**SOLICITATION AMENDMENT
MODIFICATION DE L'INVITATION**

| Title - Sujet IOS Guardhouse | |
| Solicitation No. - N° de l'invitation F1700-204430/A | Amendment No. - N° modif. 004 |

Solicitation Amendment 004 is raised to issue Addendum 003 and Addendum 004.

SCALE
AS NOTED
START DATE
DRAWING NUMBER
E110
5 OF 11
REVISION

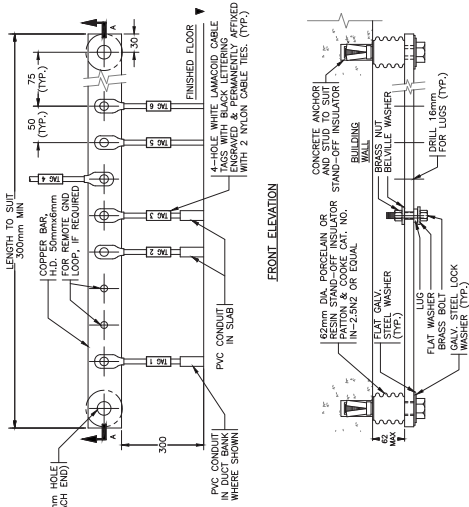
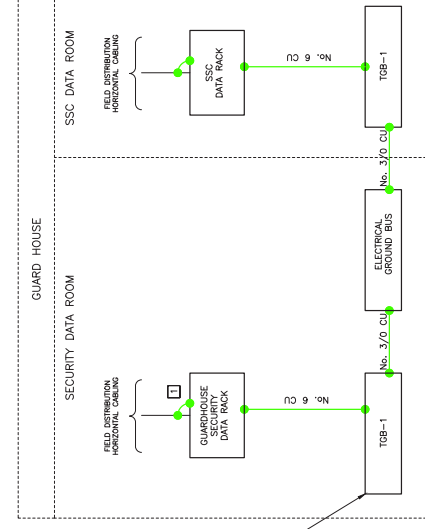
- 1.1 Drawing E110: Delete Electrical Drawing E110, Rev. 1. Replace with Electrical Drawing E110, Rev. 2.
 - 1.1.1 Accessible washroom door controls added.
 - 1.1.2 Extent of surface raceway at desk modified.
 - 1.1.3 Keynotes modified.
- 1.2 Drawing E111:
 - 1.2.1 Delete Keynote 3 "Install data cabling and leave coiled in cable tray with 3m of slack, for future connection to patch panel in security data rack"
 - 1.2.2 Insert Keynote 3: "All data cabling installed in tray shall be coiled above data rack location with a minimum of 3m of slack, for connection in rack by others. This contractor shall terminate and test all data cabling installed as part of this contract."
- 1.3 Drawing E515: Delete Electrical Drawing E515, Rev. 0. Replace with Electrical Drawing E515, Rev. 1.
 - 1.3.1 Accessible washroom door control detail added.

- 3.1 Q: Page E110 note 16 states all data lines are to be SSC unless noted otherwise. And that they are to be installed by other (rough in only). Is the electrical Contractor to supply anything other than rough in for this project? Racks equipment cables terminations or just conduit, cable tray, and blank covers? I will supply rough in only as per note 16 on E110. Please clarify if otherwise.

- 3.2 Q: Page E110 Note 3 – What do we need to allow for this

3.3 Q: Security room 107 indicates two ceiling mounted receptacles, but two floor mounted data in the same location, please confirm if this is correct & if not what is required in these locations.

3.4 Q: Note 15 – Does not appear on the drawing, please confirm location if needed.

A: Provide rough-in only as indicated. Where identified by keynote 19, also provide cables, terminations, and data outlets as required. All other data work shall be completed by Shared Services Canada. Provide data rack, horizontal PDU, UPS and electrical bonding only as indicated in drawings.

A: This note is for information only. All work associated with these two access controllers is by others.

A: All symbols shown on the drawing are for ceiling mount receptacles and data. No floor mount symbols are shown.

A: Note 15 is shown on Area Enlargement 1 of drawing E110.
